# TECHNICAL SERVICE BULLETIN

NO. 72 D 3

Clutch Release Bearing

MG Midget

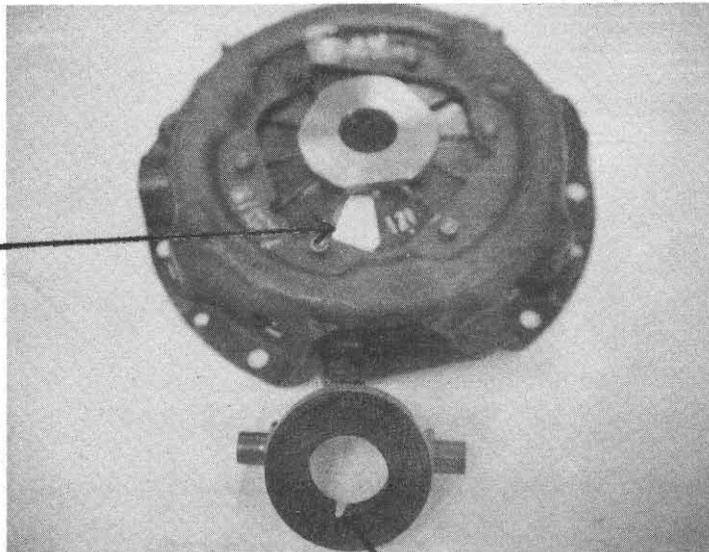
Commencing at serial number GAN5U111496, a revised material for the clutch release bearing, part number GRB107, was incorporated. The new bearing can be identified by a groove or a ridge in the internal diameter of the carbon.

In addition, a reduced clamping load on the clutch assembly was introduced, identified by buff colored paint on the release fingers, instead of blue paint for the present assembly. The new release bearing can be used with either clutch assembly.

The following illustration indicates the location of the identification marks.
